The Village at Banfield Woods **Executive Summary of Submittal**

We are pleased to present you with a proposal for an Open Space Planned Unit Development (OSPUD) of 22 single-family dwelling units to be served by a private road which will be built to town standards.

47361.00 DR RCK FB
CK JUM CADFILE
DETAILS C-39

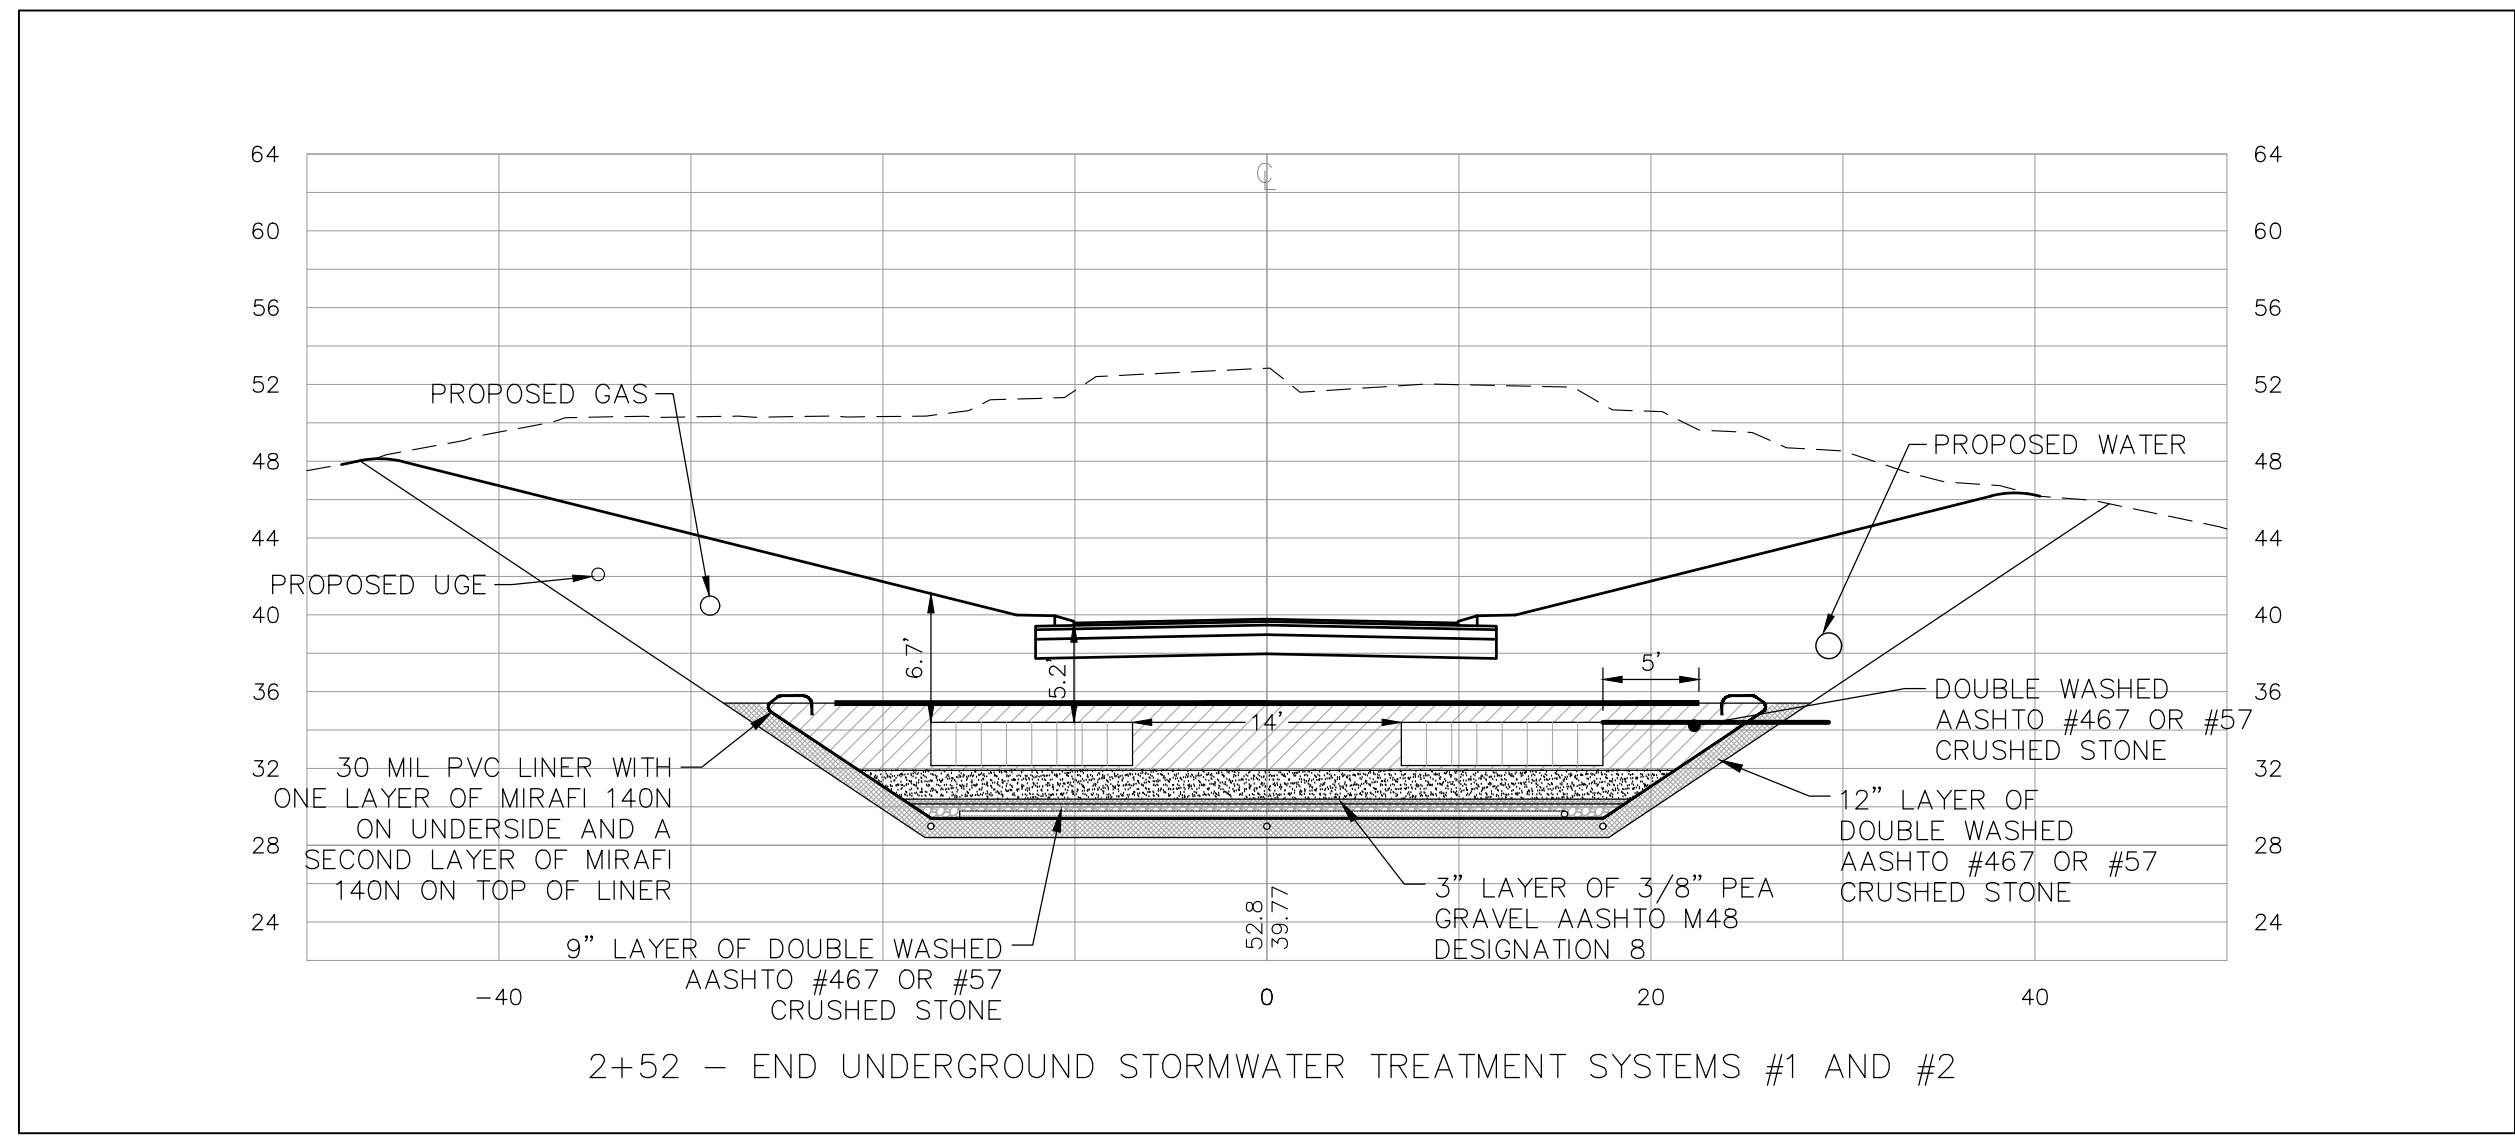
capabilities situated directly beneath each proposed R-Tank installation. As shown on Sheet C-39 of the site plan, stormwater tributary to the planned R-Tank installations is to be “filtered” through an 18 inch thickness of “filter soil mix” comprised of ASTM C-33 concrete sand, sandy loam and organic matter in a manner identical to a typical bio-retention system or rain-garden installation exposed to atmospheric conditions. Typical of most bio-retention systems, “filtered” stormwater then accumulates in successive 3 inch and 9 inch thicknesses of pea stone and crushed stone respectively, situated directly beneath the planned filter soil mix and atop an impermeable membrane, prior to discharge via a network of 4 inch diameter perforated pipes located at the base of the USTS.
